Service Bulletin

101 East Seneca Bancroft, IA 50517	Bulletin #: SB000003	Date: December 7, 2015
Prepared by: Bob Mortenson	Phone # 515-885-2398	Page: 1

Inform Aluma dealers and owners that 8605T, 8610T and 8612T trailers may have misaligned welds that may contribute to a failure of the trailer's axle mount weldment.

Figure 2

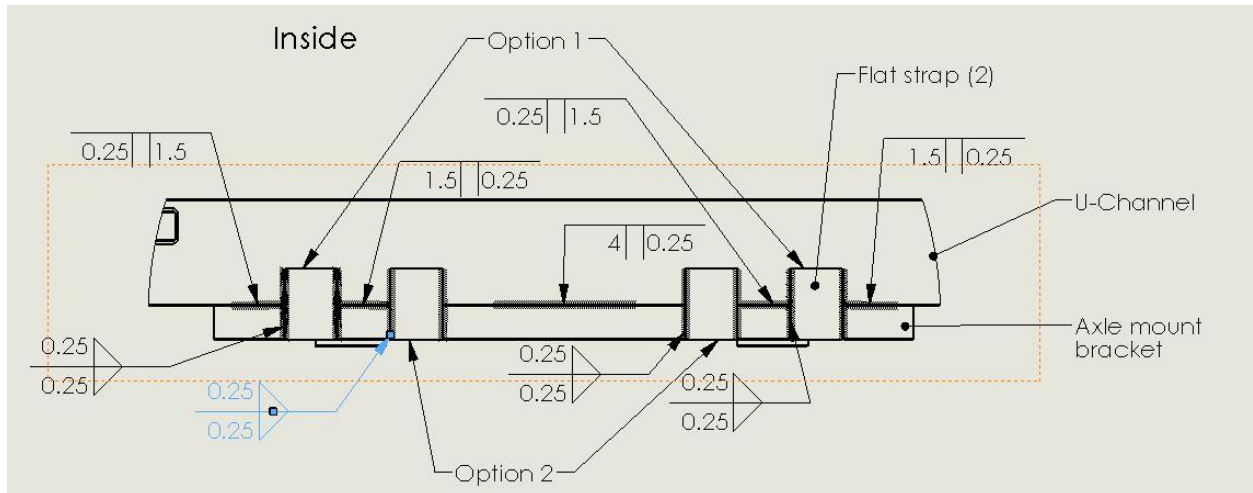
- 4.0 Add flat strap to inside of axle mount as shown in Figure 1 and 2. Depending on condition of welds found in steps 5 or 6.
 - 4.1 Option 1: Flat strap must be located 2 inches from end of axle mount if flat strap can be placed flat onto axle mount and U-channel and then weld.

- 4.2 Option 2: flat strap is to mount next to end of weld on axle mount bracket. Weld joint using a 1/4" butt weld.
- 5.0 For any misaligned welds prepare surface to be rewelded. All welds shall be centrally located in joints. This will provide weld leg length and groove weld to ensure joint penetration necessary for an acceptable weld. Weld joint using 1/4" butt weld at least 3 inches long.

Figure 3

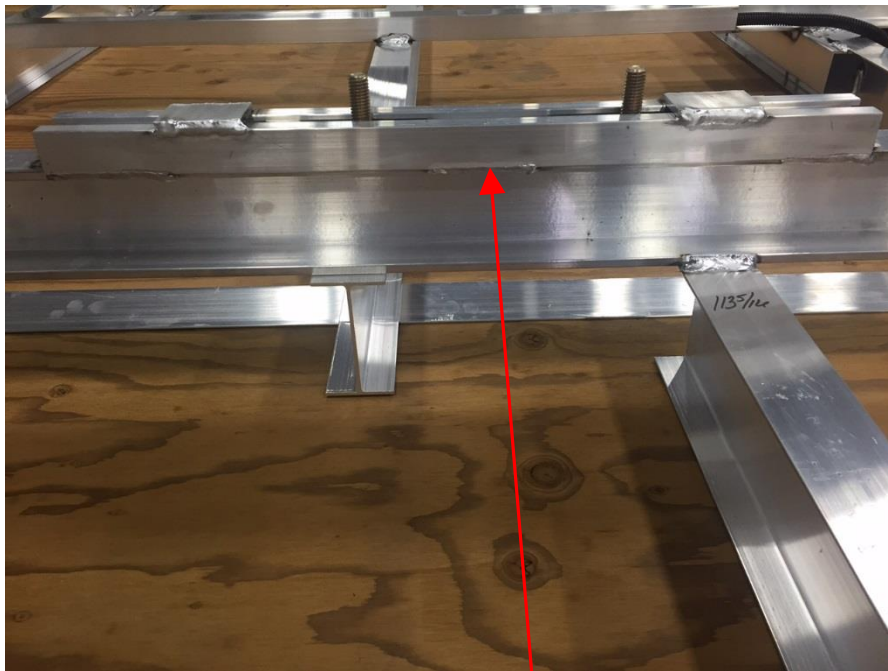
- 2.0 Remove and secure tires and hardware to be reinstalled later in step 8.
- 3.0 Inspect inside weld joint of axle mounts and U-channels for misalignment of weld or any cracks in welds. See Figure 1. If any defects are present proceed to inspecting axle mount outside welds and verify that there are no signs of base material damage. Repair all suspect welds using step 6. See Figures 3 and 4.

Outside axle mount: inspect for poor quality welds.

- 6.0 For any cracked or poor quality welds, grind cracked or poor quality weld and prepare any surrounding surface areas to be welded. Weld joint using 1/4" butt or fillet weld at least 3 inches long.
- 7.0 Person performing retrofit should be qualified and proficient aluminum welder. **Caution:** Use appropriate PPEs when preparing surface and welding. **Note:** Ensure that wiring harness is not damaged during welding.
- 8.0 Reinstall tires torque lug nuts to 110 ft/lbs. For more detailed information, refer to Aluma Owner's manual.
- 9.0 Verify work has been completed and all tools and hardware is secured. Raise trailer and remove jack stands.
- 10.0 Lower trailer and perform driving functional test to verify trailer is traveling correctly.
- 11.0 For more detailed information, always refer to Aluma Owner's Manual.
